**DOCUMENT 00 90 00  
ADDENDUM**

**ADDENDUM NO. [1]                      Date: February 21, 2018**

**RE:                      EAU CLAIRE AREA SCHOOL DISTRICT  
SECURE ENTRANCES AT:  
LAKESHORE ELEMENTARY, 711 LAKE ST.  
MANZ ELEMENTARY, 1000 E. FILMORE AVE.  
CHIPPEWA VALLEY MONTESSORI, 400 CAMERON ST.  
EAU CLAIRE, WISCONSIN 54701  
HSR PROJECT NO. 17057**

**FROM:                  HSR Associates, Inc  
100 Milwaukee Street  
La Crosse, WI 54603  
(608) 784-1830**

**WALL TYPES**  
1 1/2" = 1'-0"

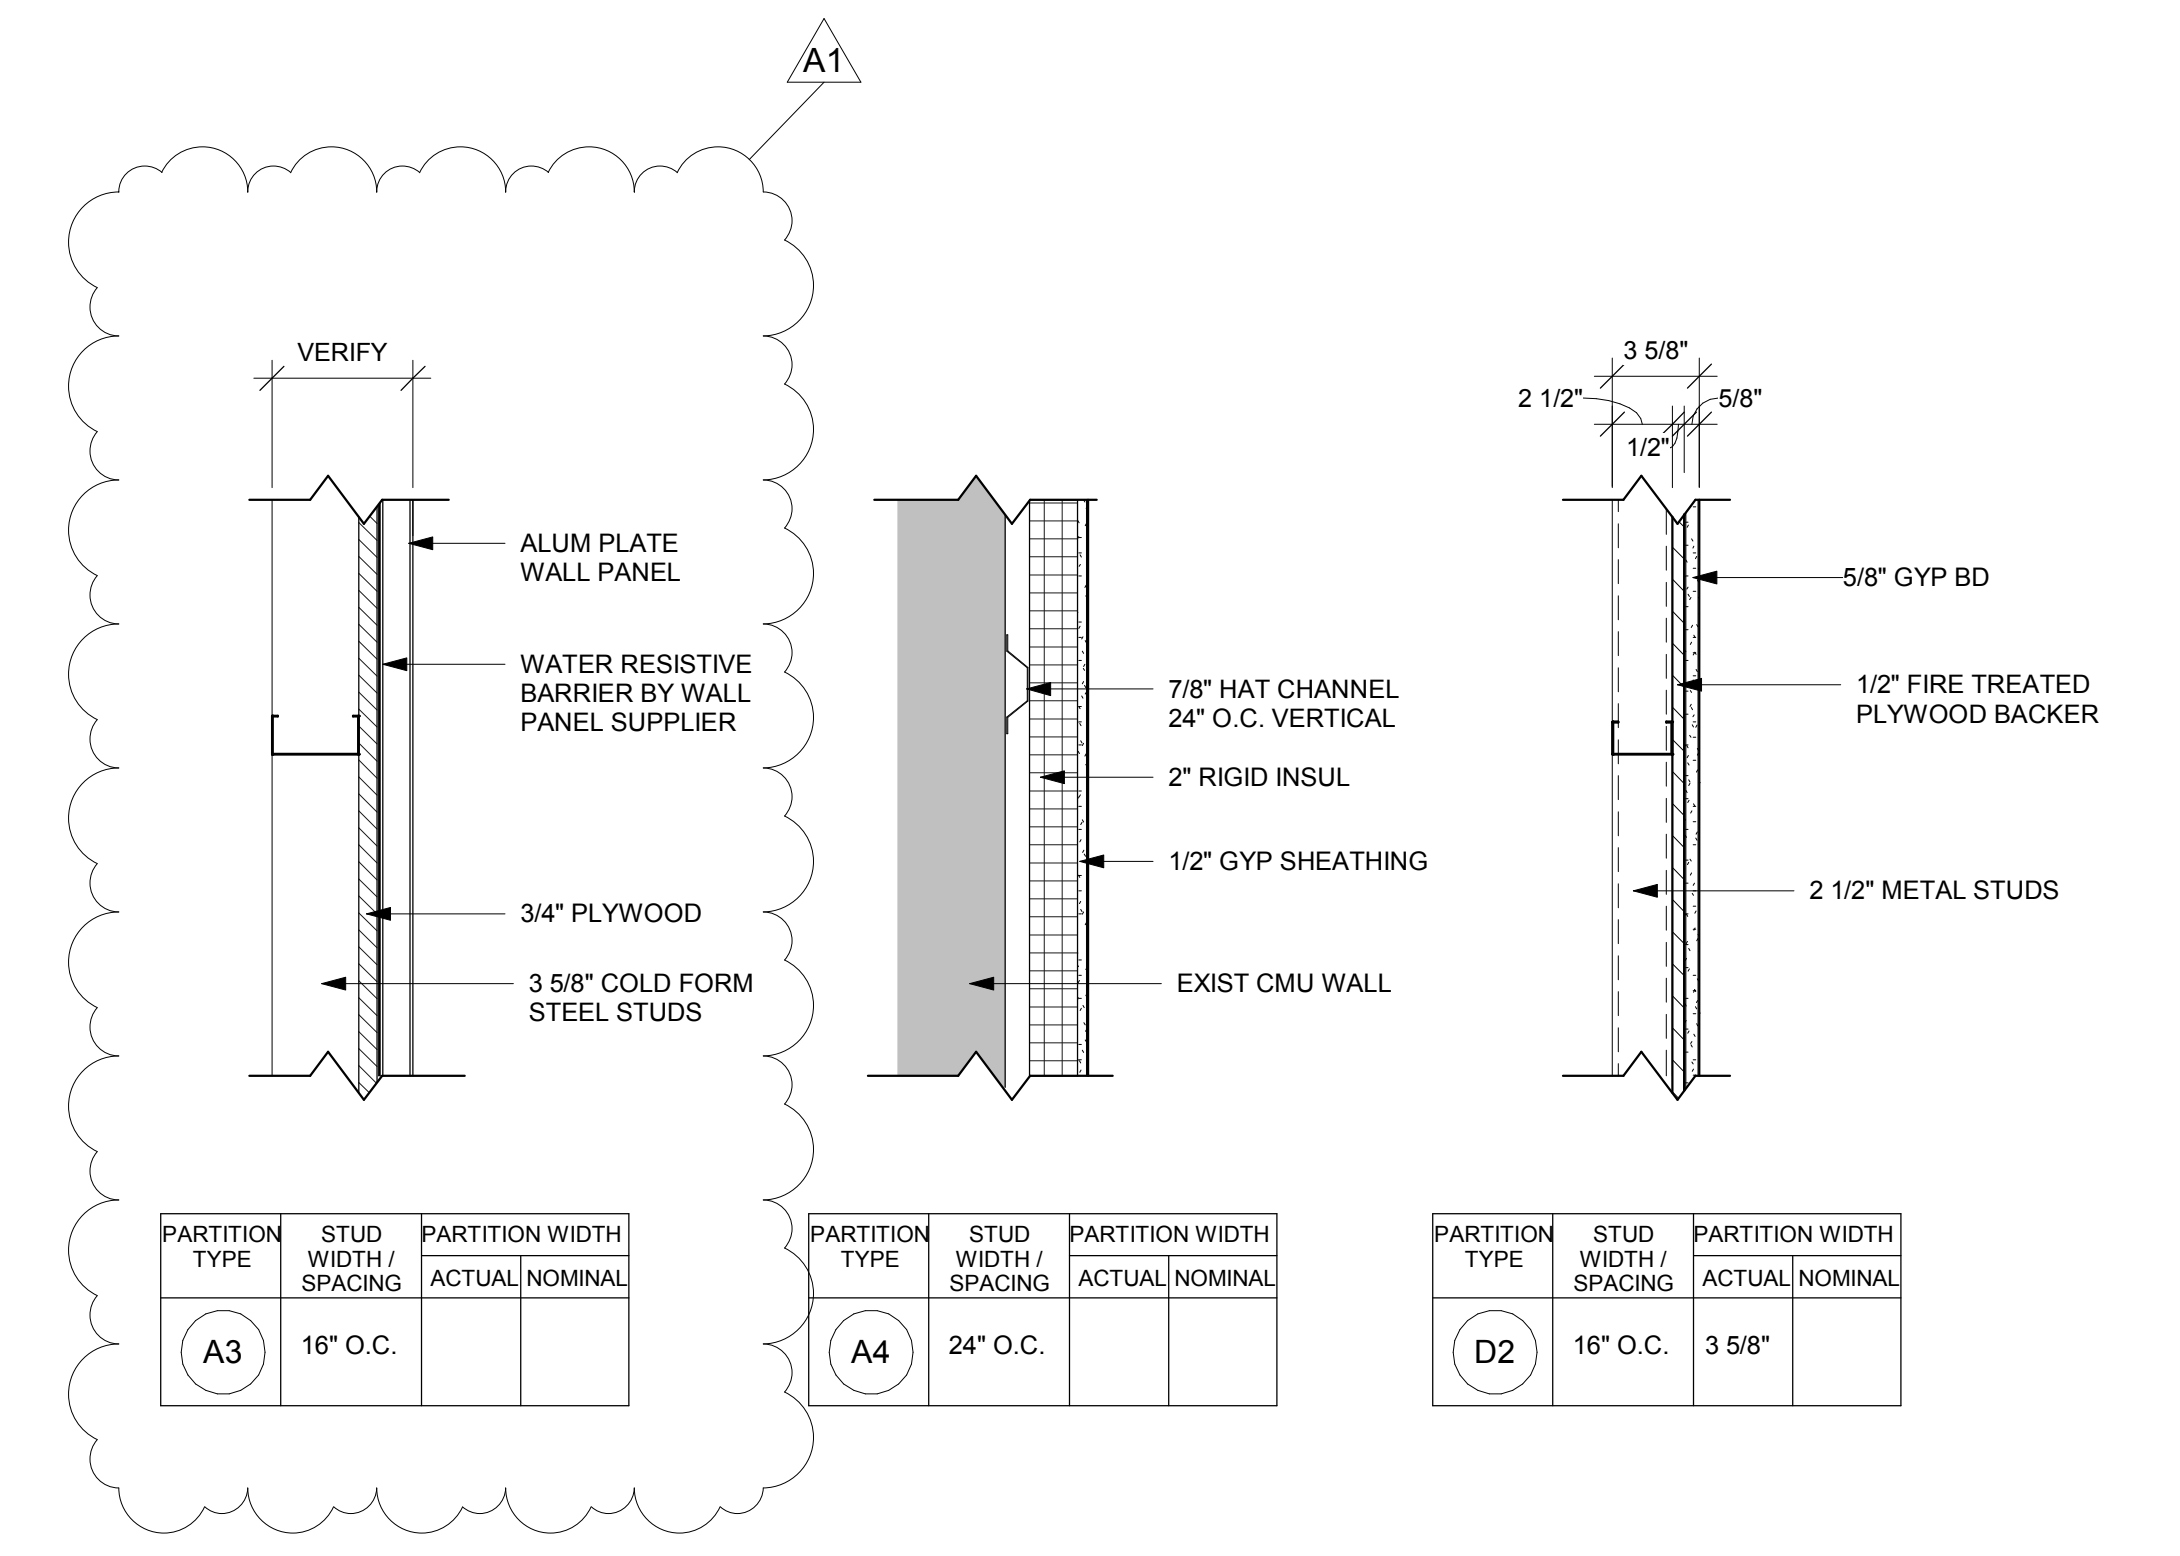
4. LAKESHORE: Sheet A200R ELEVATIONS, SECTIONS AND WALL TYPES 30 x 42 attached hereto
  - a. Revise Wall Type "A3".
5. LAKESHORE: Sheet A600 DOOR SCHEDULE AND DETAILS
  - a. At Door Schedule, Door 100D, change Hardware Group to "3".
6. MONTESSORI: Sheet E100 ELECTRICAL PLAN
  - a. 2E100: Add security camera at west end of building next to Door 2A, 13 ft. AFF.
  - b. At light fixture schedule, add the following as equal manufacturers;  
Cooper Lighting  
Hubble Lighting  
Day-Brite.
